Technical Bulletin: 2011-XXR

2006 – 2009 FJR1300

Factory Modification Campaign: Ground Wire Junction

EXAMPLE OF DAMAGE

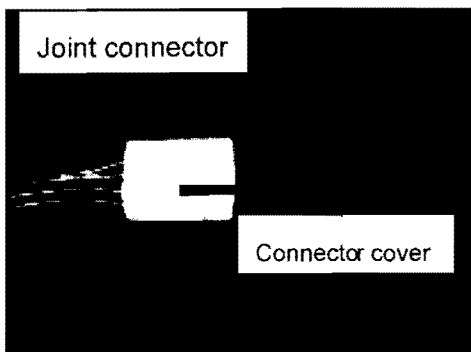
3. Remove the connector cover and bus bar from the joint connector. On operated units, check for any signs of damage to the joint connector.

4. If the ground joint connector is damaged, the entire wire harness itself must be replaced.

Follow Service Manual information, including the Cable Routing section, to install a new wire harness. Do not continue with wire sub-lead installation instructions. Put a punch mark above the Vehicle Identification Number (VIN) as described under *Identification Procedure* on page xx. See *Warranty Information* on page xx for instructions on submitting a claim for wire harness replacement.

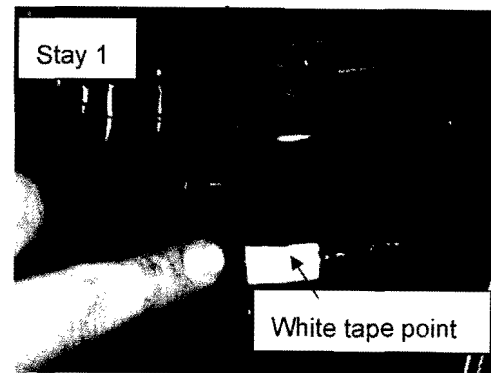
14. Fasten point 1 – Using the long cable tie (383mm) from the kit, combine the wire sub-lead with the main harness and stay 1 at the white tape point of the wire sub-lead. Face the end of the cable tie upward as shown, and then cut off the excess end of the cable tie.

15. Fasten point 2 – Using the medium cable tie (202mm) from the kit, combine the wire sub-lead with main harness, right radiator fan motor lead, negative battery lead, and starter motor lead. Face the end of the cable tie outward. Position the cable tie in front of the air deflector. Make sure the cable tie is on the fan motor lead's protective sleeve, and then cut off the excess end of the cable tie.

Fasten point 1~ 4

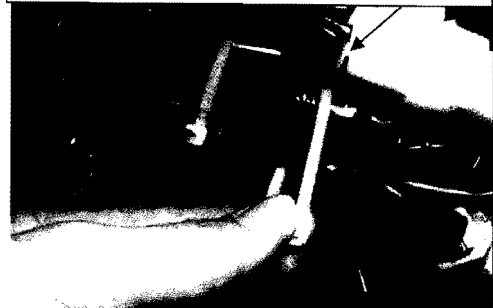
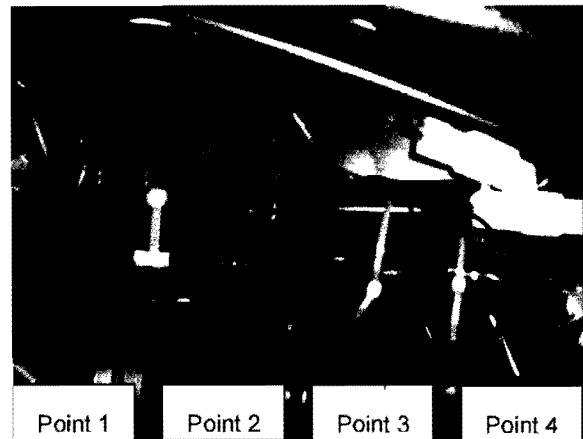
16. Fasten point 3 – Using a short cable tie (145 mm) from the kit, combine the wire sub-lead with main harness, right horn lead, right radiator fan motor lead, and stay 1 at the original point. Face the end of the cable tie outward. Make sure to install the cable tie on the fan motor lead's protective sleeve. Do not cut off the end of the cable tie.

17. Fasten point 4 – Using a short cable tie (145 mm) from the kit, combine the wire sub-lead with the main harness at the black tape point of the main harness at point 4. Face the end of the cable tie outward. Do not cut off the end of the cable tie.

Fasten point 5 and 6

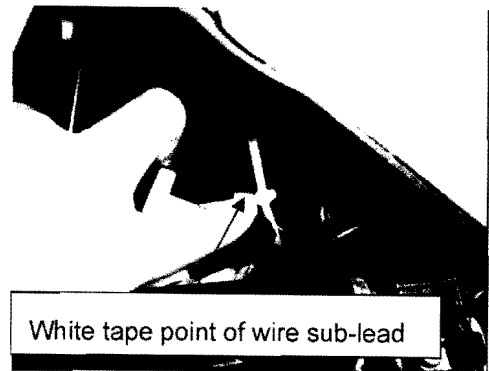
18. Fasten point 5 – Using a short cable tie (145 mm) from the kit, combine the wire sub-lead with the main harness at the white tape point of the wire sub-lead. Face the end of the cable tie forward. Do not cut off the end of the cable tie.

19. Fasten point 6 – Using the last short cable tie (145mm) from the kit, combine the wire sub-lead with main harness assembly by the white tape point of the wire sub-lead at point 6. Face the end of the cable tie forward. Do not cut off the end of the cable tie.
